KENSINGTON POINTE MASTER DEVELOPMENT PLAN:

NOVEMBER 2021 UPDATE

Kensington Pointe: Transit Oriented Development Master Plan

No.	County Rezoning Conditions	Compliance Status & Response	Comments
1	The 4.76 acre tract (the "Project Site") shall be developed in general conformity with the conceptual plan entitled "Exhibit A" and entitled Kensington Pointe and dated June 29, 2020 by the Department of Planning and Sustainability.	Design Complies	Final survey reflects 4.73 acres.
	Development shall comply with the intent of MARTA Transit-Oriented Development (TOD) Guidelines by moving the buildings close to the Kensington Road and Memorial Drive rights-of-way with parking located behind the proposed buildings.	Design Complies	The buildings and site layout were designed to the minimum required distance from approved setbacks.
	Building height shall be five stories for the residential buildings and a minimum of thirty feet tall for the office building.	Design revised, but compliant	Due to cost & design constraints the buildings do not exceed 4 stories at any given section. The office is now two stories instead of three with each floor at 12ft for a combined height of 24ft. Above the offi

Site Plan Comparison

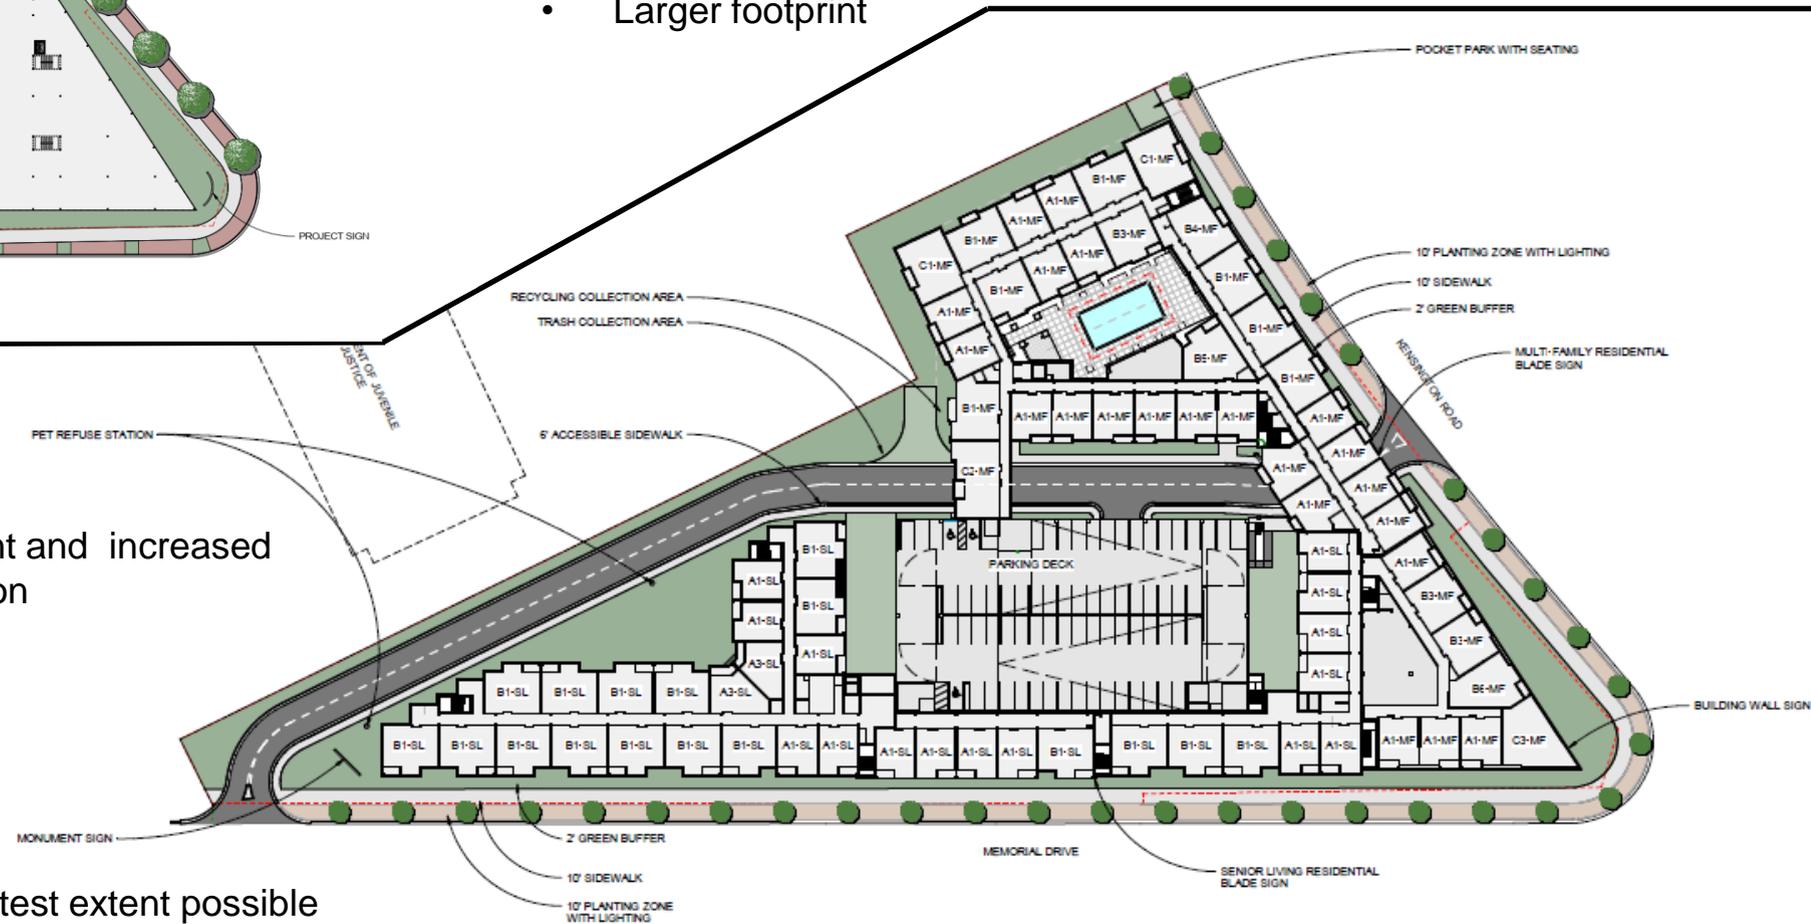
- Residential
 - 5 floors
 - Market Rate- increased 2bd & 3bd unit count
- Office
 - 3 floors at 30,000sf
 - Standalone bldg. with sweeping glass windows
- Parking Deck
 - 4 floors
 - Larger footprint

- Residential
 - Height reduction to 4 floors
 - Market Rate- reduced 2bd & 3bd unit count and increased 1bd count to accommodate height reduction
- Office
 - 2 floors at 28,000sf
 - 2 residential floors stacked above
- Parking Deck
 - 6 floors(1 sub-grade)
 - Smaller footprint
- Meets all Zoning Approval Conditions to the greatest extent possible

Figure 1

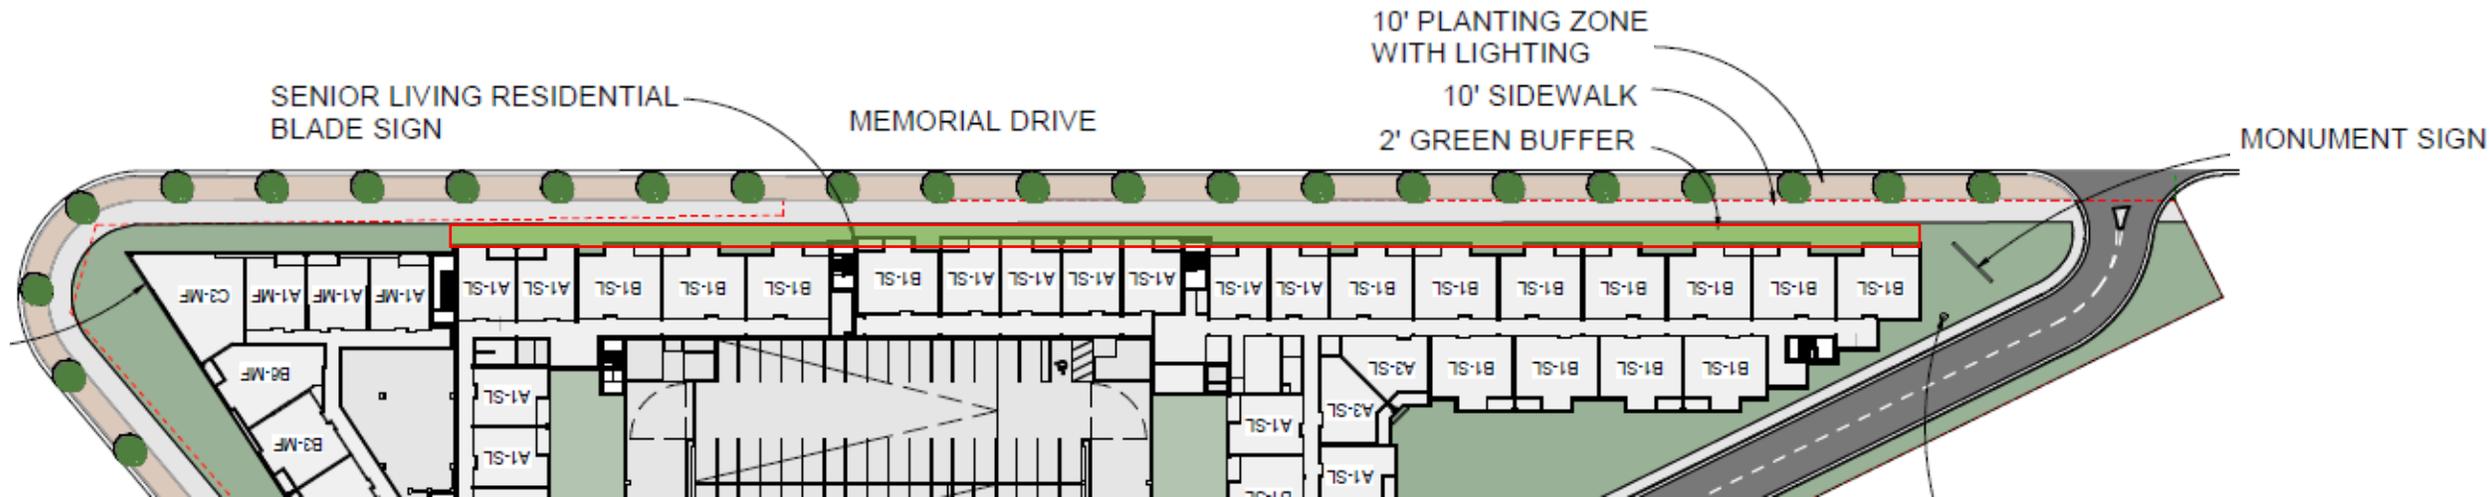
The streetscape zone along Memorial Drive adheres to conditions outlined in the zoning approval using the existing right of way designations. Please reference the Site Plan Overlay Depiction (Figure 1) on the following page which presents the Memorial Drive side of the Kensington Pointe conceptual plan. It shows the curb, 10' Planting Zone, and 10' Sidewalk as well as a 2' green buffer to the edge of our building.

Repositioning setbacks based on new right-of-way lines would encroach upon the footprint of the building. This would negatively impact the buildability of the Senior Living units as well as a portion of office. Please reference the light green overlay outlined in red which serves to demonstrate how the increased setbacks would affect the Kensington Pointe site. The Elevation Overlay Depiction (Figure 2) illustrates that 76 units (nearly 60% of the Senior Community) would be eliminated should the increased setbacks be required.
